DESIGN AND CONSTRUCTION MANUAL DESIGN MODIFICATION REQUEST

PROJECT NAME: The Retreat at Hook Farms 2nd Plat

Re: The Retreat at Hook Farms Second Plat-Stream Buffer Variance Request

Re: The Retreat at Hook Farms Second Plat – PL2021165
Stream Assessment Design Memorandum

**STREAMWAY CENTERLINE PROFILE
 NATURAL CHANNEL ASSESSMENT**
 THE RETREAT AT HOOK FARMS
 SECOND PLAT
 LEE'S SUMMIT, MO
 2022

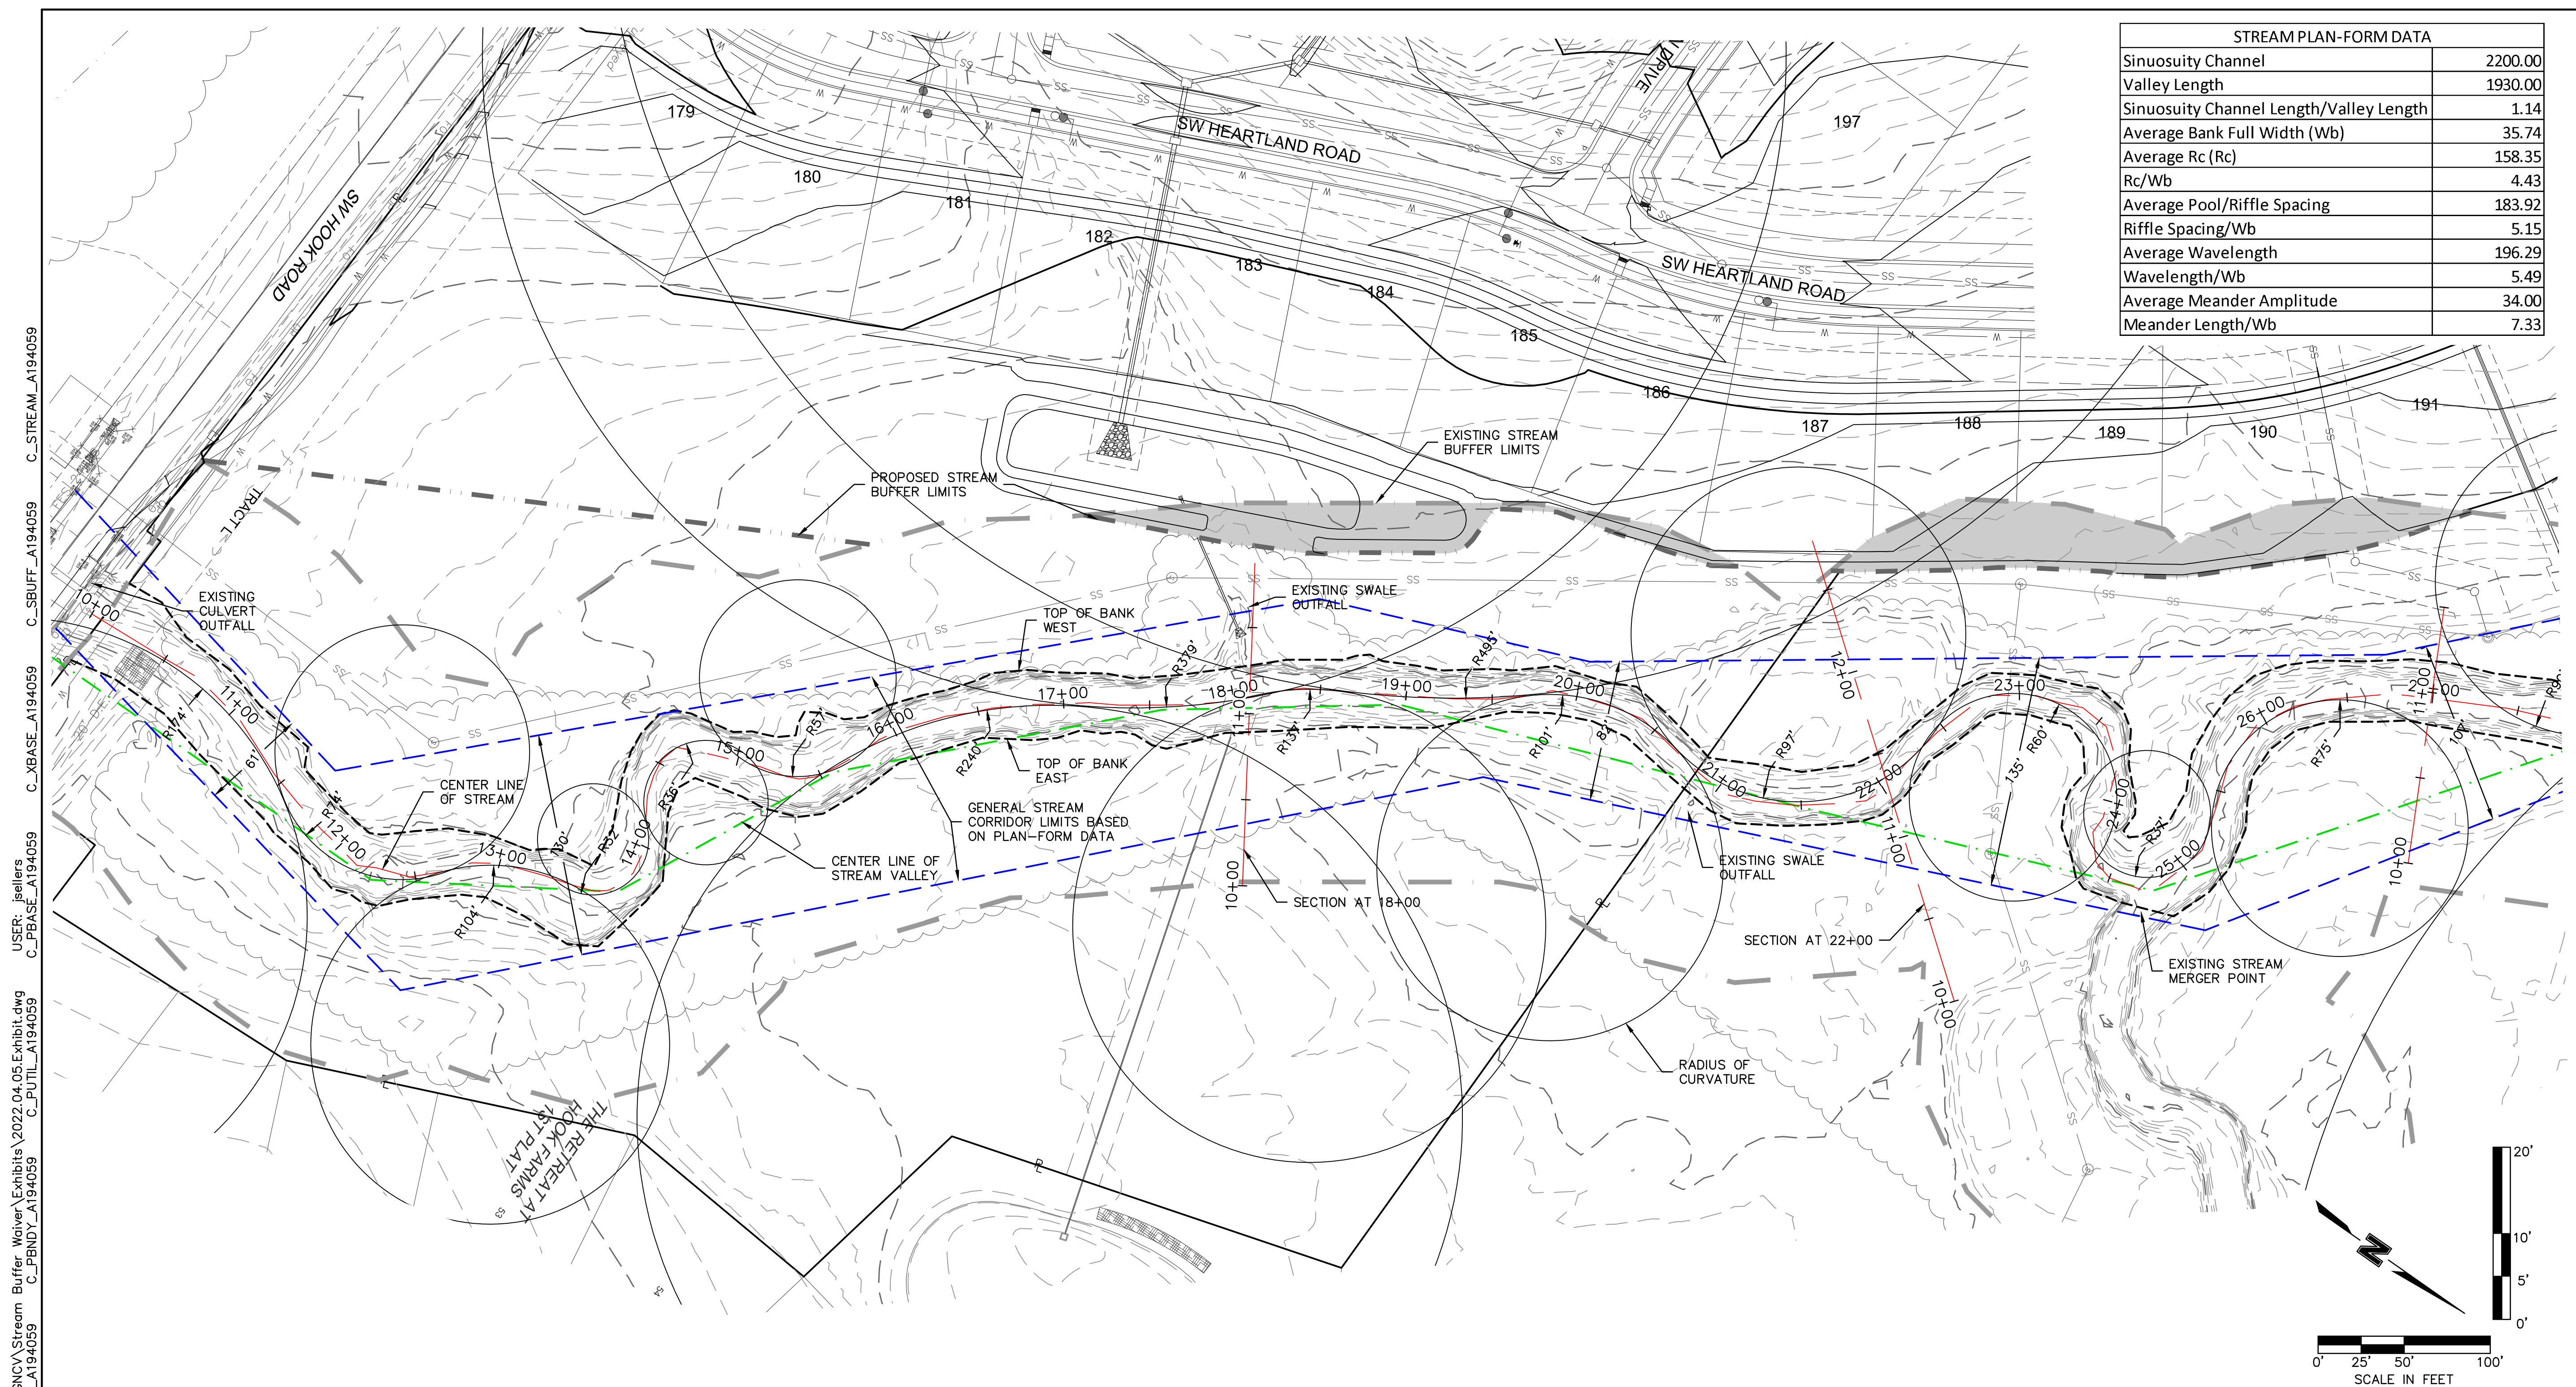
The existing stream information and the plan-form analysis have performed and included in the attachments of this memo. The Plan-Form Ratio lies within the typical range with the exception of meander length/full bank width.

The ratio for the meander length/full bank width falling out of typical range appears to be a result of shorter wavelengths caused by concentrated discharge through the culvert crossing Hook Road and the convergence of two streams, both outside of the area of this waiver request.

Based on the plan-form analysis, general steam corridor limits have been shown on the Stream Assessment Plans. The stream corridor limits show that the proposed development will not interfere with the natural meandering of the stream.

STREAM BUFFER PLAN
SITE GRADING & SITE DISTURBANCE PLANS
THE RETREAT AT HOOK FARMS
SECOND PLAT

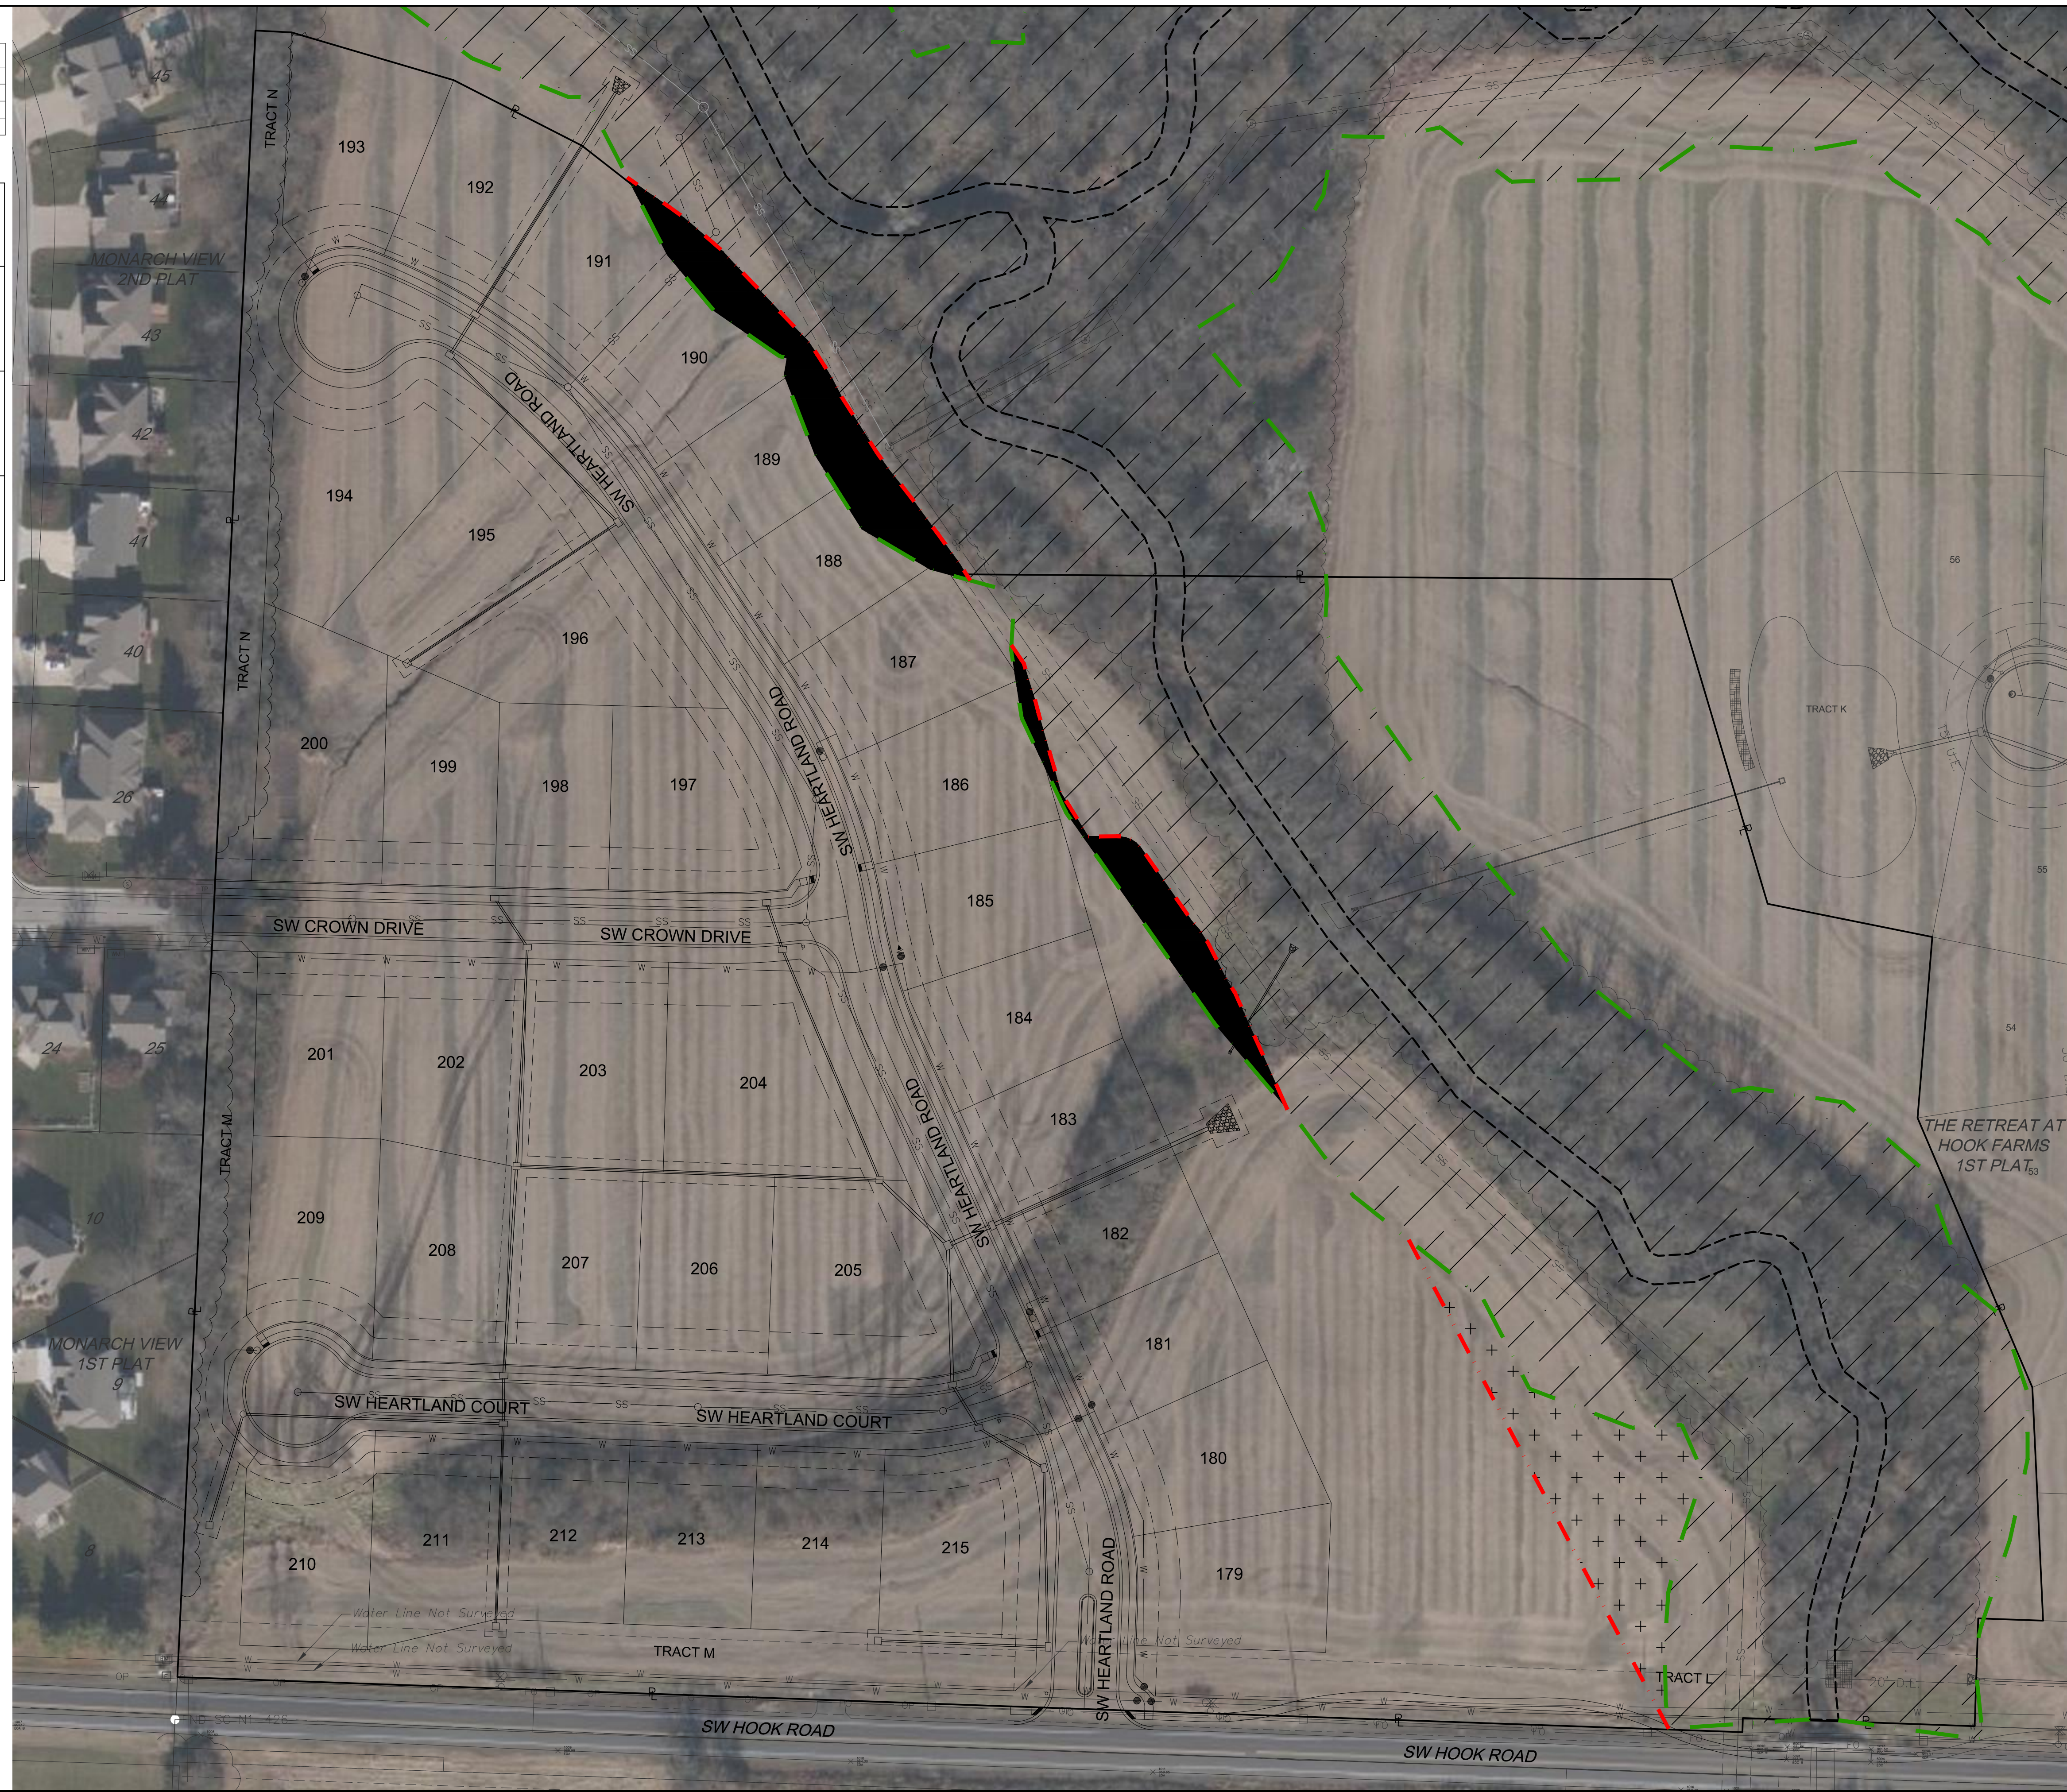
The stream buffer setbacks encroach on lots 186-191 of The Retreat at Hook Farms Second Plat. The city has requested an easement be placed over the stream buffer limits. From review of historic site imagery and site visits, this area has been under agricultural use for many years. Agricultural uses routinely disturb areas which prevents the growth of mature riparian vegetation. Due to the no active stream buffer existing in this area, we are requesting the setback zone be adjusted to remove the lot area and follow the rear lot lines.

While this request is asking to remove stream buffer setback zones, per the enclosed exhibit, this is limited to an approximate maximum setback distance of 35 feet, resulting in a total area of 0.378 acres. Areas outside of the shown disturbed limits, will maintain required setback distances and existing vegetation around the creek.

We are requesting the city approve with waiver/modification request to allow the final stream buffer setback to be reduced where it encroaches on lots, as shown in the attached exhibit. Should you have any questions about this request please reach out to us at jsellers@olsson.com or 816.442.6044.

STREAM BUFFER ZONE CALCULATIONS PRE-DEVELOPMENT AND PROPOSED DISTURBANCE		
	EXISTING STREAM BUFFER ZONE TO REMAIN	N/A
	DISTURBED STREAM BUFFER ZONE	0.378 AC.
	ADDITIONAL STREAM BUFFER GRANTED	0.400 AC.
